COUNCIL ACTION FORM

REQUEST: APPEAL OF CONDITIONS OF APPROVAL OF SITE PLAN FOR 2516 LINCOLN WAY

RE: Minor Site Development Plan for 2516 Lincoln Way (SDP-17-05)

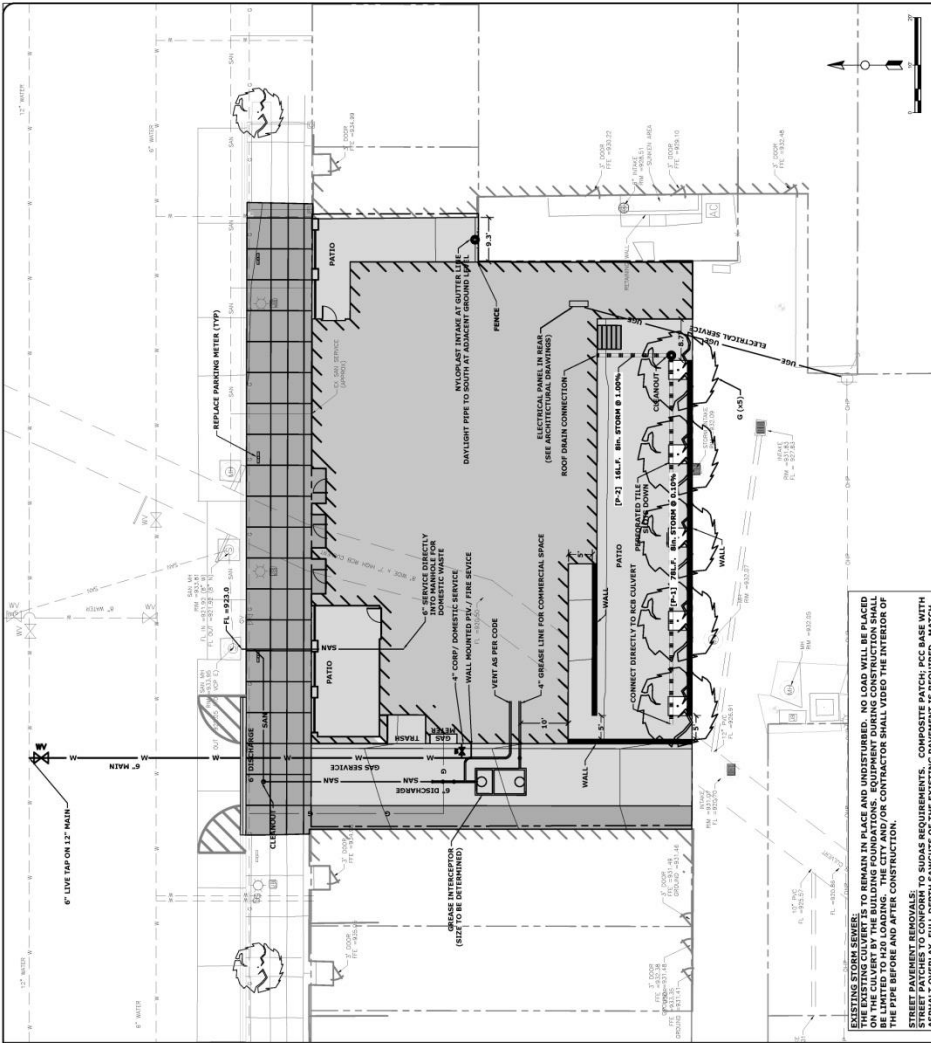
Staff believes that this opening is warranted for access to the trash receptacle and to access the underground grease trap serving the commercial uses. However, staff believes the opening can function without the safety issue of having access across the sidewalk and onto Lincoln Way.

There is always a safety issue when vehicles exit a street by crossing a sidewalk—even more so due to the heavy usage of the Lincoln Way sidewalk. The owner cannot guarantee that access through this driveway will be limited to only early morning traffic and that access will be in-bound only. Once there, the driveway could be used at any hour of the day or night and in either direction, as the access points on Welch Avenue and Hayward Avenue show.

2. No driveway to Lincoln Way is permitted. A permanent barrier of decorative bollards that are 3 to 4 feet in height must be installed along the north property line for the open area between the building and the west property line to ensure there is no vehicle access across the sidewalk to Lincoln Way. Prior to installation, provide a detail to the Planning Division for the bollards.

1 SITE PLAN
1" = 10'-0"

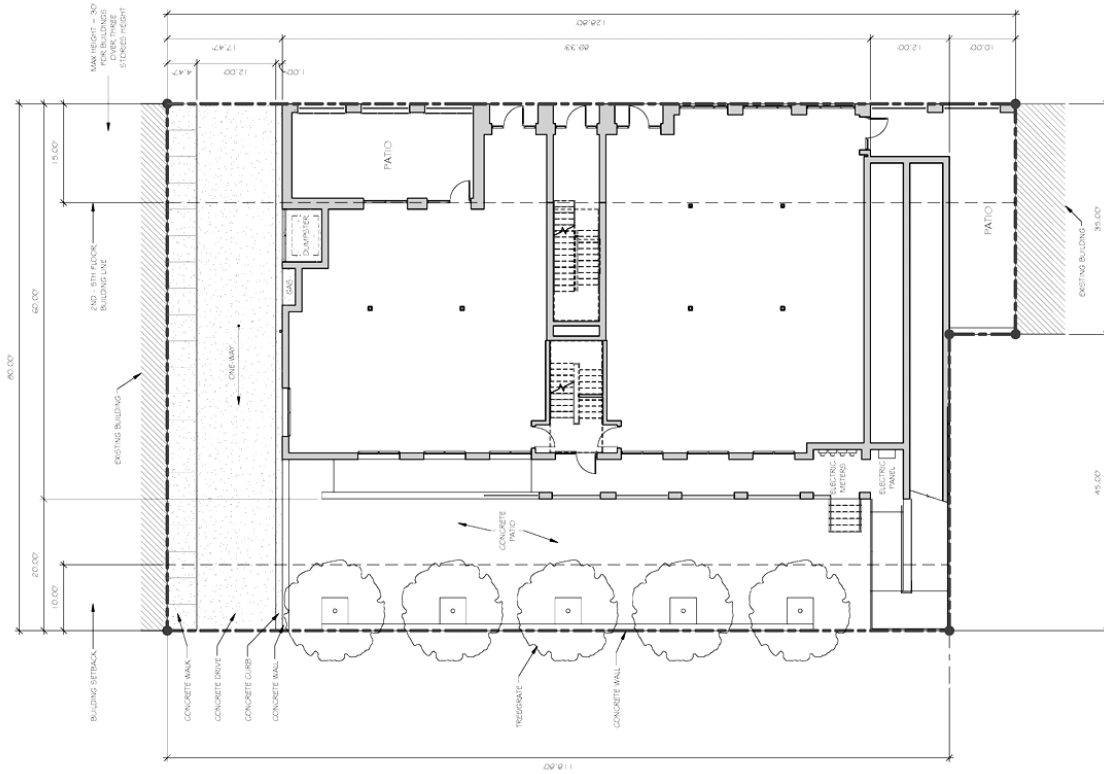
The applicant proposes using this opening along the west side of the property to access the side and rear of his project for trash collection and loading and unloading with a curb cut onto Lincoln Way.

The owner has provided a twenty foot wide opening between his building and the building adjacent to the west. Within this area, the owner has recessed an enclosure for the trash receptacle. He has also shown a curb cut onto Lincoln Way to allow access through this area. The owner claims that he has no access to the “parcel” in the rear of the building and that, therefore, he is allowed to use this mid-block areaway as his driveway.

He claims that no parking will be lost on Lincoln Way as the trucks accessing this driveway will arrive very early in the morning when no vehicles are parked on the street. Therefore, the parking meters can remain and the only physical change would be a curb cut.

The owner claims that trucks will enter from Lincoln Way and exit out onto either Hayward Avenue or Welch Avenue. There will be no backing onto Lincoln Way.
